SUBJECT: RHODE ISLAND ATOMIC ENERGY COMMISSION – ISSUANCE OF
AMENDMENT NO. 30 TO FACILITY OPERATING LICENSE NO. R-95,
RHODE ISLAND NUCLEAR SCIENCE CENTER (TAC NO. MF1044)

AMENDMENT TO FACILITY OPERATING LICENSE

Amendment No. 30
License No. R-95

SAFETY EVALUATION BY THE OFFICE OF NUCLEAR REACTOR REGULATION

FIGURE 6.1 - ORGANIZATIONAL CHART

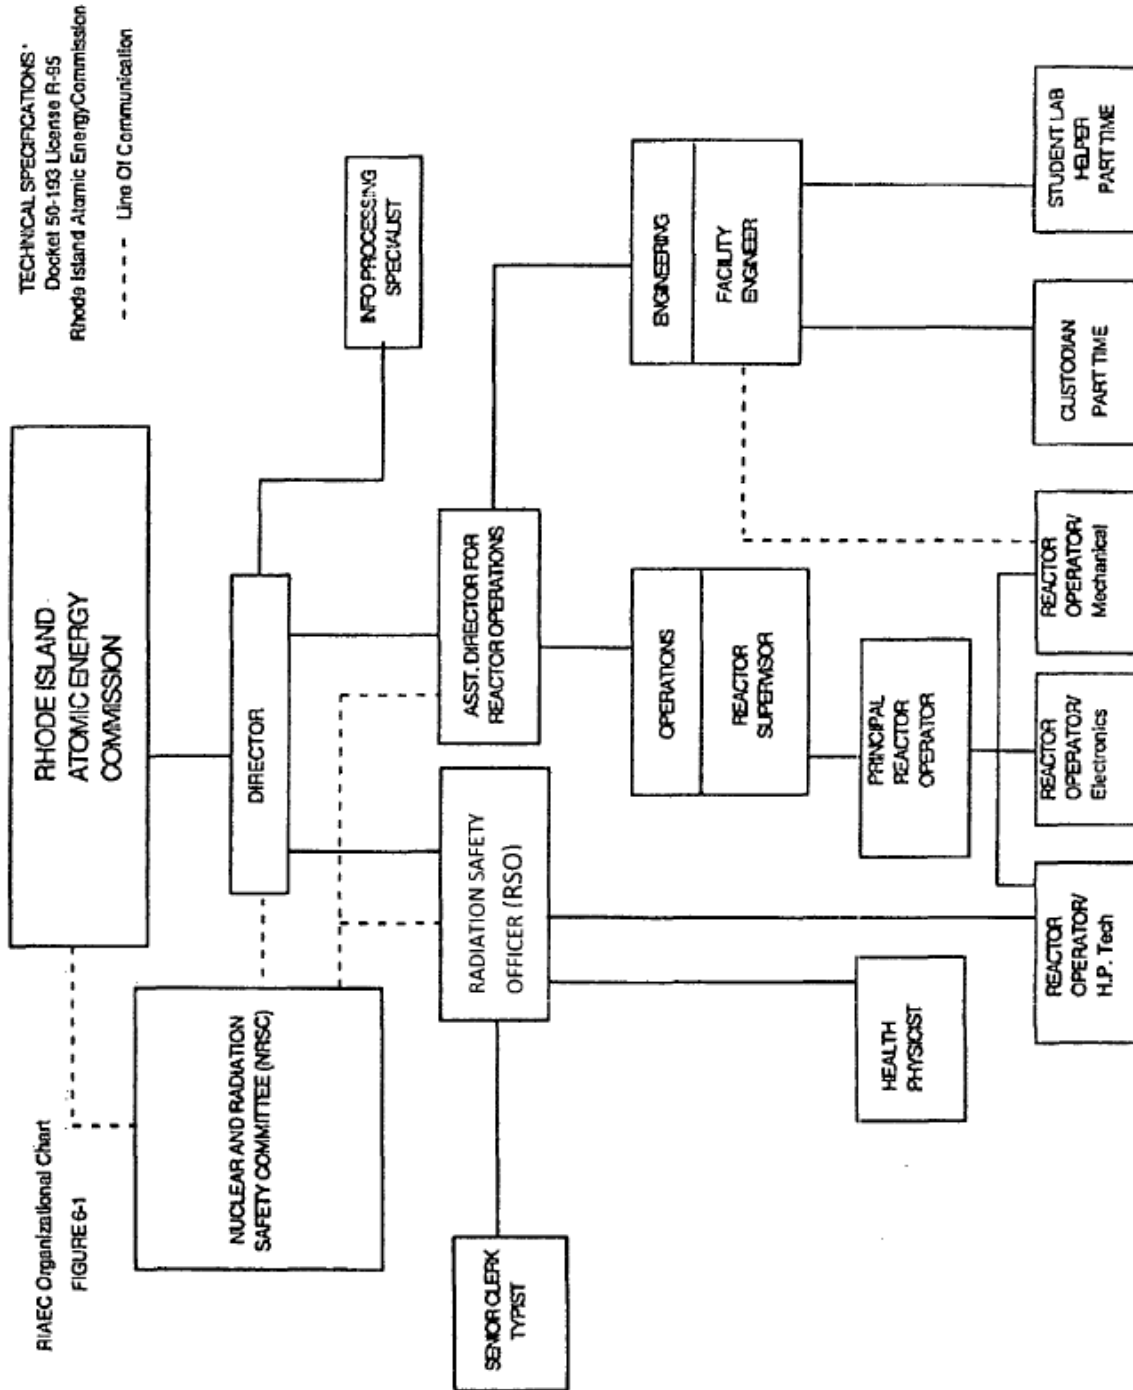
The amendment makes a change to TS 6.1, "Organizational Chart," which changes the title of "Assistant Director for Radiation Safety" to "Radiation Safety Officer."

The licensee proposed an amendment to change TS 6.1, "Organizational Chart," which changes the title of Assistant Director for Radiation Safety.

The current RINSC TS 6.1, has the following title:

- Assistant Director for Radiation Safety (Radiation Safety Officer)

In its letter dated February 7, 2013, the licensee has requested to change the title to:

- Radiation Safety Officer
